**CCB 8225**  
**Pre and Post Change Summary**  
**PCN #: CAAN-03OQBK734**

# Lead-Frame Comparison

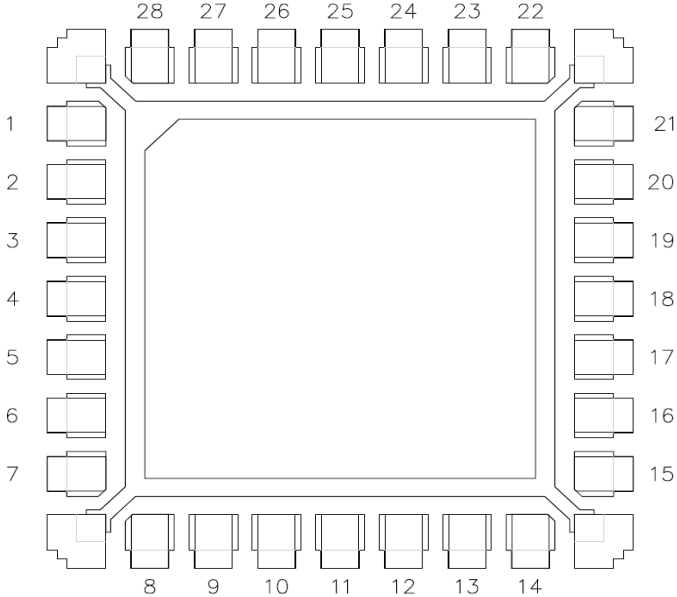
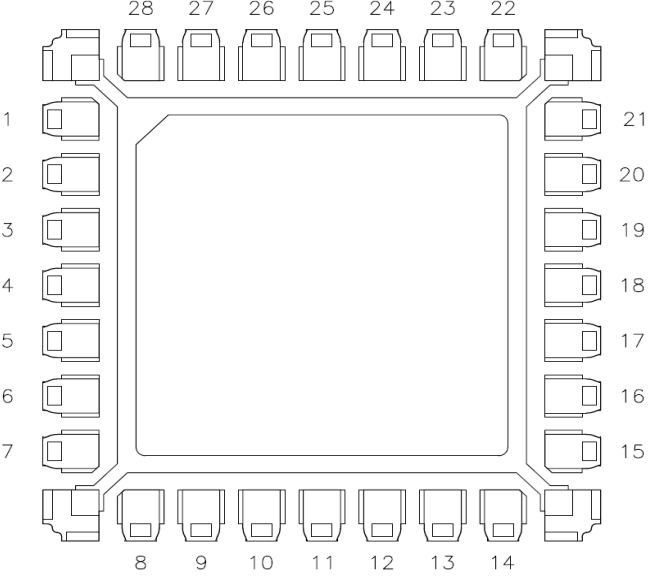
| NSEB (UTL-1)  | MMT   |                  |                             |               |  |                            |                  |                             |                    |
|---|---|------------------|-----------------------------|---------------|--|----------------------------|------------------|-----------------------------|--------------------|
| <table border="1" style="width: 100%; border-collapse: collapse;"> <tr> <td style="padding: 5px;"><b>Lead-Frame Material</b></td> <td style="padding: 5px;"><b>EFTEC-64T</b></td> </tr> <tr> <td style="padding: 5px;"><b>Lead-Frame Lead Lock</b></td> <td style="padding: 5px;"><b>Dimple</b></td> </tr> </table> | <b>Lead-Frame Material</b>  | <b>EFTEC-64T</b> | <b>Lead-Frame Lead Lock</b> | <b>Dimple</b> | <table border="1" style="width: 100%; border-collapse: collapse;"> <tr> <td style="padding: 5px;"><b>Lead-Frame Material</b></td> <td style="padding: 5px;"><b>EFTEC-64T</b></td> </tr> <tr> <td style="padding: 5px;"><b>Lead-Frame Lead Lock</b></td> <td style="padding: 5px;"><b>Half Etched</b></td> </tr> </table> | <b>Lead-Frame Material</b> | <b>EFTEC-64T</b> | <b>Lead-Frame Lead Lock</b> | <b>Half Etched</b> |
| <b>Lead-Frame Material</b>  | <b>EFTEC-64T</b>  |                  |                             |               |  |                            |                  |                             |                    |
| <b>Lead-Frame Lead Lock</b>   | <b>Dimple</b>   |                  |                             |               |  |                            |                  |                             |                    |
| <b>Lead-Frame Material</b>  | <b>EFTEC-64T</b>  |                  |                             |               |  |                            |                  |                             |                    |
| <b>Lead-Frame Lead Lock</b>   | <b>Half Etched</b>  |                  |                             |               |  |                            |                  |                             |                    |
